Re: EPA Comments on Revised Work Plan
Kokomo Dump Site (C564)
1130 South Dixon Road
Kokomo, Indiana
Docket No. V-W-13 C-018

Work Plan Modifications

SAMPLE LOCATION MAP KOKOMO DUMP 1130 S. DIXON ROAD KOKOMO, HOWARD COUNTY, INDIANA

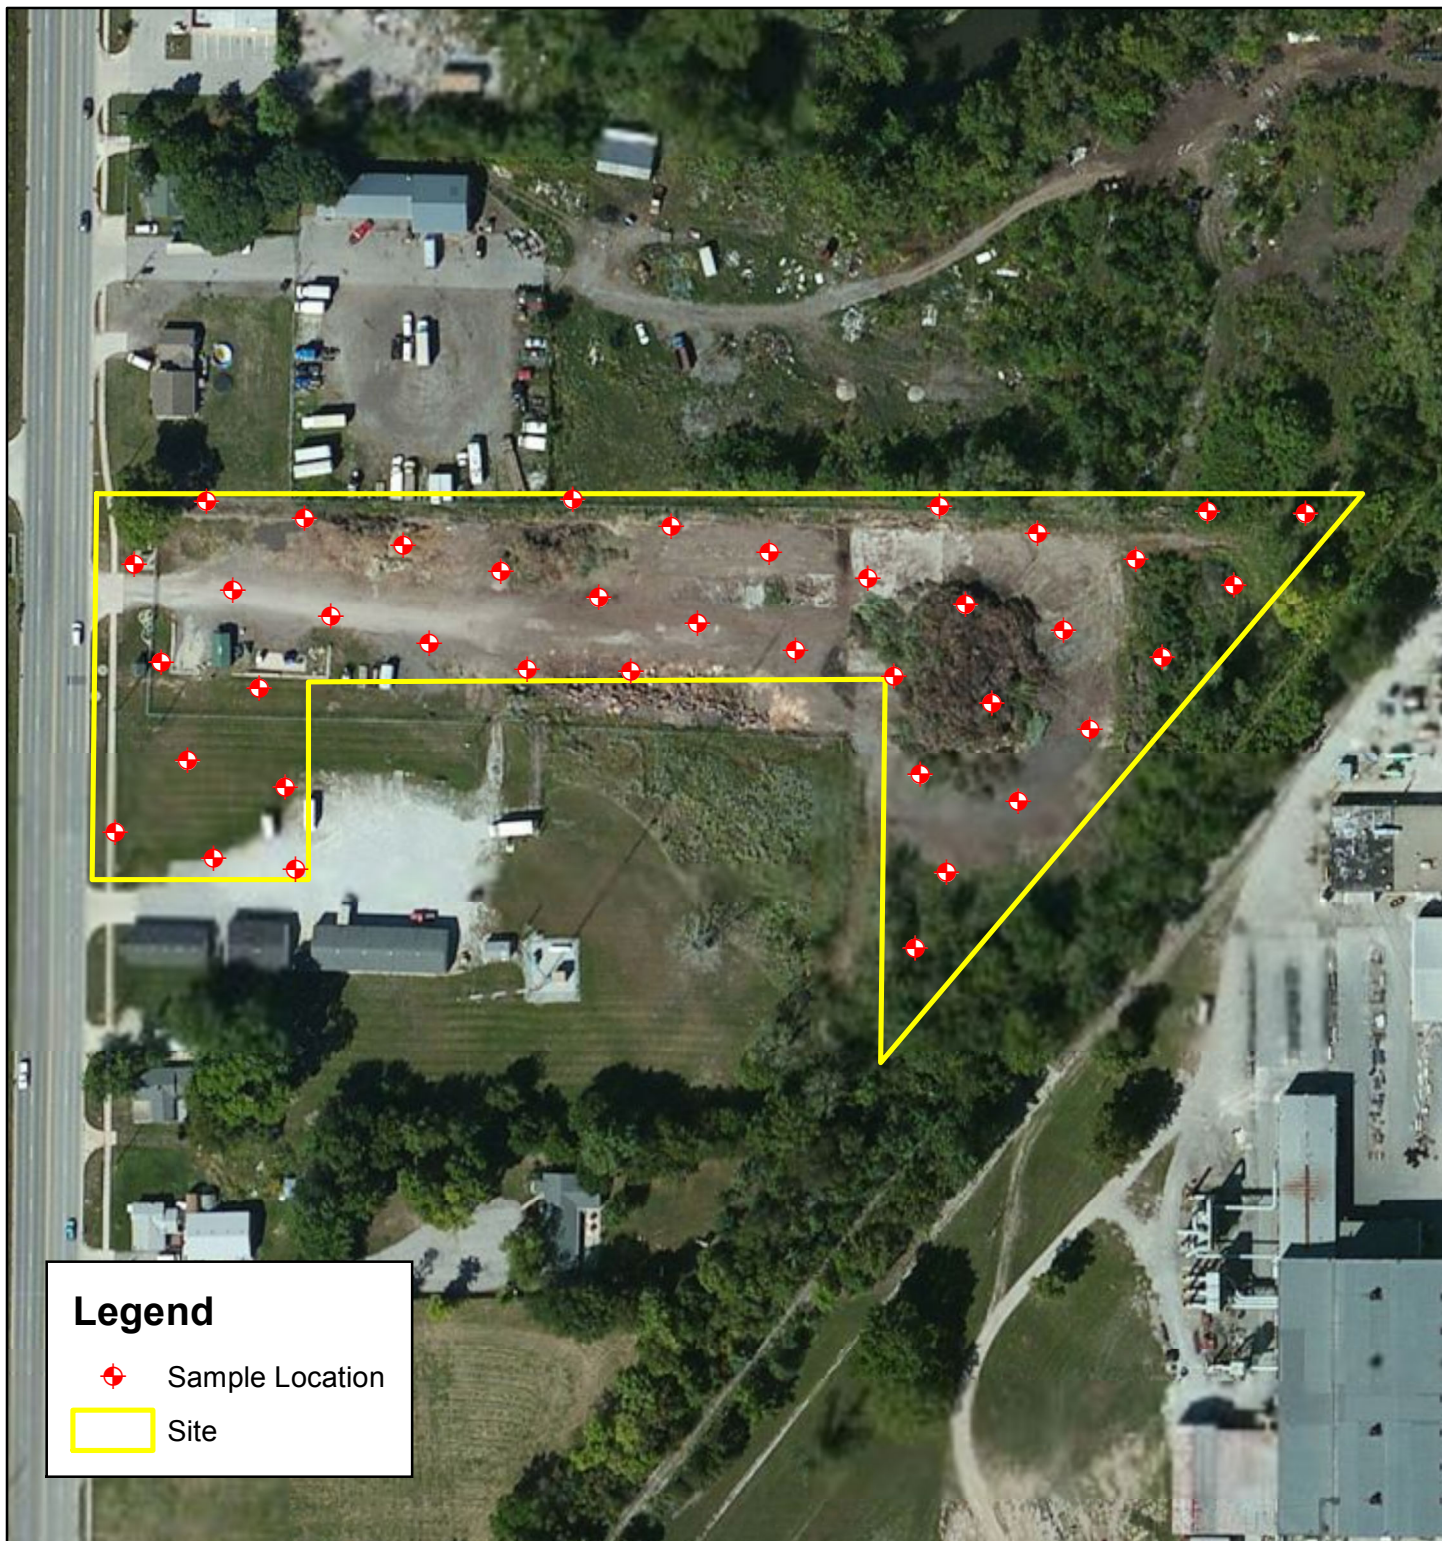
- b. It is unclear what sampling design is used in the Work Plan, although this information was requested in EPA’s comments on the previous Work Plan. The objective of soil sampling is to determine the nature and extent of contamination. A random-start equilateral triangular gridded sampling approach is the most appropriate sample design. The attached figure displays co-located surface and subsurface soil sampling locations using the above design; this figure should be used to update the Work Plan, figures, and tables.
